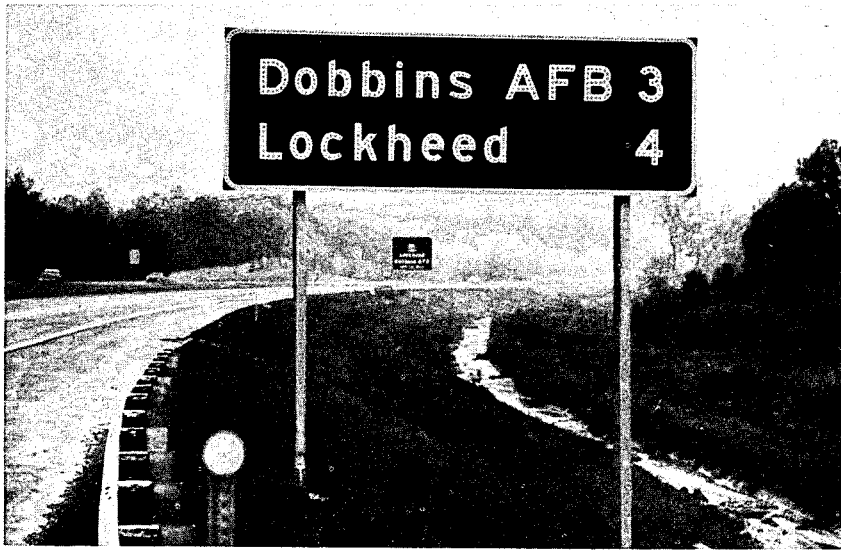
Here is another interesting series, going the other way, going south. Dobbins Air Force Base here is labeled 3 miles, Lockheed 4 miles. It is a bit difficult to understand, because when you get up there, they appear to be across the street from each other.

You go from this sign to the sign you see, through the legs of this sign, in the background. That sign says a half mile. Instead of saying Dobbins and Lockheed, this says Lockheed and Dobbins. This violates the principle of good signing practice, which maintains continuity in signing messages.
